Dear Quentin Libois, we thank you for the many helpful comments, which certainly improved the manuscript. Especially pointing out the small but important details, which were missing so far, was very welcome. The detailed replies on the reviewer's comments are structured as follows: The individual reviewer comments are given in bold letters, followed by our reply. Changes/additions made to the text are enclosed in quotation marks.

Figure 3: Spectral transmission, reflection, and absorption/emission coefficients of the Germanium window for the wavelength range covered by the TIR imager. Included are in addition the response functions (transmission coefficients, dashed/dotted lines) of the four narrow-band channels.

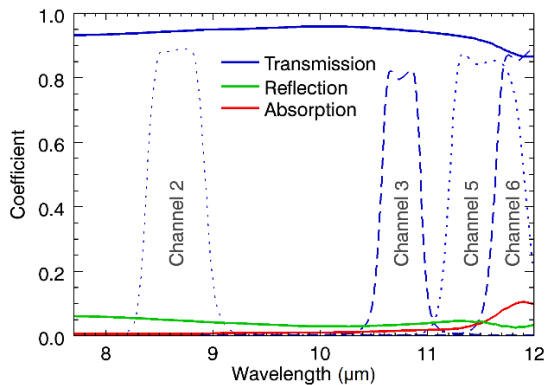
Eq. 1: how where the different parameters of this equation determined? Was the method validated by cross-calibration against a black-body?

The parameters were obtained from the manufactures of the window and the lens and validated by cross-calibrations with a black body. We've added some more information on how to handle the equation and from where we got the values. In this regard, we also included a plot of the spectral transmission, reflection, and absorption/emission coefficients and had to reorganize some paragraphs to improve the readability. The new version reads like this:

"... The specific absorption/emission is given by ε , the reflection by R , and the transmission by T . The subscripts denote the two coefficients of the window (win) and the imager's lens (lens). The spectral ε , R , and T of the window as provided by the manufacturer and validated by cross-calibrations with a black body are shown in Fig. 3. Overall, the Germanium window has a high average transmissivity of 93.95 % in the wavelength range from 7.7 μm to 12 μm . The spectral behavior of the reflection coefficient is rather constant over the entire range with about 5 % on average, while the absorption/emission coefficient is almost negligible for the VELOX channels 2 and 3, but affects longer wavelengths (up to 10 % for Channel 5 and 6). The emission coefficient of the lens is 0.15. Although, this value seems to be quite large, it results in a rather low contribution to the composed signal (≈ 0.75 %), because it only corresponds to the radiation emitted by the lens. For the application of Eq. 1 the window parameters were integrated for the filter response function of the selected spectral channel...."

Figure R1. Correlation between the cloud-free simulations and the maximum brightness temperature values displayed in Fig. 6, which represent cloud-free measurements over the warm ocean. Left: old version, right: new version.

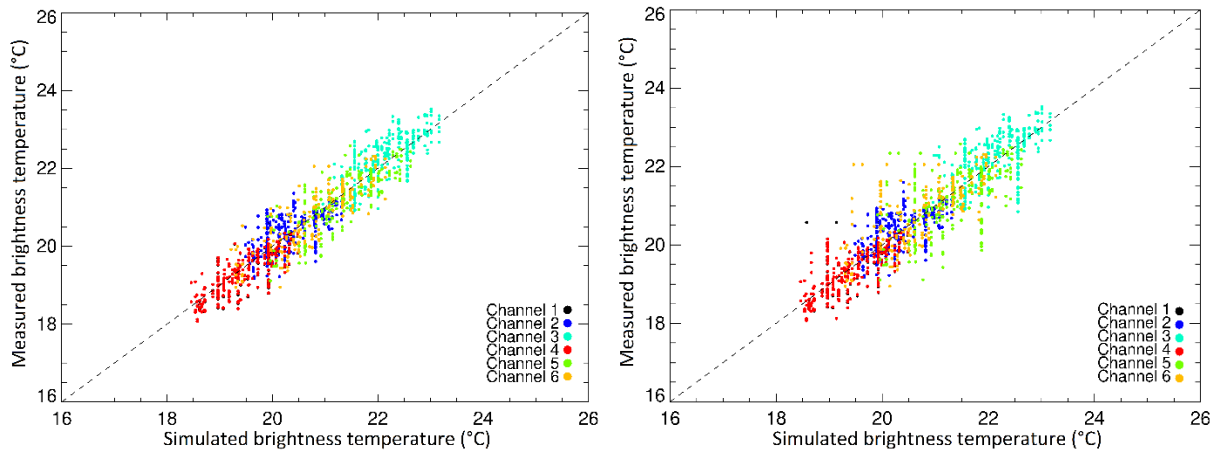
I.300: are the differences between simulated and estimated cloud-free BT due to differences in atmospheric state, or could they be solely explained by measurement uncertainty? The differences should be compared to measurement uncertainty on the one hand, and to simulation variability on the other hand. Are the points away from the 1:1 line actually those acquired far from a dropsonde?

You are right. Here, we've certainly missed some explanation in the text. We performed an analyses following your proposal. To investigate if the larger differences are related to the distance to the next dropsonde, we've tested it once with all data and once with measurements acquired during the circular

flight sections only. Within the circular flight sections, we usually had dropsonde launches approximately every 5 min. In comparison, during the flight sections to ships or buoys only one or two dropsondes within one hour were released. The differences are illustrated in Fig. R1 below. The largest differences can be observed for measurements that were performed far away from the next dropsonde (during excursions). In comparison, the measurement uncertainties are a minor reason for these differences. This is indicated by the very similar spread of the differences derived from the different channels, although they have very different NETD ranging from 48 mK to 605 mK.

In the original version we have shown only the circular flight patterns and excluded the flight sections to the ships without explaining it. To make the point clearer we've exchanged it with the plot that includes all data now. Furthermore, we elaborated the explanation.

"The correlation R between the maximum envelope fit and the simulations is 0.84 (Pearson correlation). Tests have shown that the measurement uncertainties have a minor influence on these differences. Although the NETD varies significantly between the single channels, the spread of the deviations observed with the different channels shows a similar pattern. The reason for the observed differences is mainly linked to the spatial/temporal resolution of the simulations, which are limited by the

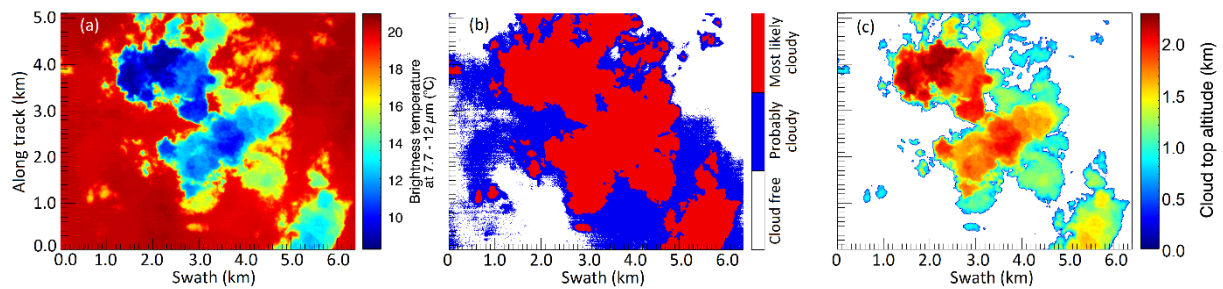
I.376: 470 m offset seems huge for a cloud mostly ranging from 600 to 1400 m. Can it really be explained by errors in actual atmospheric profile? How does an error in BT translate into an error in cloud top altitude, roughly (for the atmospheric profiles observed)?

These offsets are randomly distributed (see. Fig R1a). The mean of the offset distribution is located close to 0 m for all flights. The 25 % percentile is about 120 m. For a flight leg with low dropsonde coverage (see Fig. R1c), 50 % of the VELOX cloud top altitudes had an offset smaller than 400 m (for low temporal resolution of 1 Hz) in pointwise comparisons with WALES. This offset could be further reduced by the use of a temporally higher resolved time series (full VELOX resolution, Fig. R1b). This improvement indicates that the offsets are affected by the differences between the VELOX and WALES cloud masks, especially due to mismatches at cloud edges. A second source for larger offsets is attributed to the distance to the closest dropsonde, which introduces uncertainties in the radiative transfer simulations and the parametrization of the cloud-free atmospheric temperature offset. This is confirmed by the analysis of flight sections with a low number of dropsonde launches (2 February 2020). In these cases, the offsets increase as illustrated in Fig. R1c.

“The cloud top temperature measured by VELOX is closely linked to the cloud top altitude. This relation is commonly used in cloud top altitude retrievals from satellite observations. Here, a similar approach is used for the images from VELOX and extended by a cross-calibration with nadir-pointing cloud top altitude measurements from WALES (Wirth et al., 2021). This method allows to extend the nadir measurements of WALES to 2D maps of cloud top altitudes, which resolve the horizontally structure of shallow cumulus. To apply the cross-calibration, a first guess of cloud top altitude from VELOX is needed. It is derived from the measured brightness temperature of the thermal imager’s broadband channel 1. This first guess is necessary since there is no fixed direct relation between cloud top altitude derived from WALES and the VELOX brightness temperature along the flight path. It rather varies in time with the changing influence of the atmosphere. For the first guess, the brightness temperature is combined with atmospheric profiles from dropsondes (George et al., 2021) and radiative transfer simulations of the cloud-free atmosphere. The simulated brightness temperatures are parametrized as a function of the distance to the cloud top and used to invert the measurements.

In a second step this first guess of the VELOX cloud top altitude is cross-calibrated with the WALES cloud top altitude. The cross-calibration uses the cloud mask (“most-likely-cloudy” threshold) of VELOX (cloud mask based on the central 10 by 10 spatial pixels) and WALES. If both instruments detect a cloud, the

cross-calibration is applied, which links the first guess of the VELOX cloud top altitude to the WALES cloud top altitude in a linear relationship. At this juncture, the correction of the first guess VELOX cloud top altitude ranges between 100 m and 300 m.

Two major reasons for these uncertainties were identified; (i) an increased distance to the next dropsonde leads to uncertainties in the cloud-free simulations, and (ii) mismatches in the cloud mask by VELOX and WALES. The latter can be reduced when using the full temporal resolution of VELOX.

Considering the NETD of VELOX, the full approach allows a retrieval of 2D maps of cloud top altitudes with a vertical resolution of 40 m. As an example, Fig. 11c shows the derived cloud top altitude for the cloud scene from 9 February 2020. Cloud top altitudes below 600 m might be nonphysical and are related to very thin clouds or cloud edges. These low cloud top altitudes probably results from a contamination of the signal by the emission of the ocean below.”
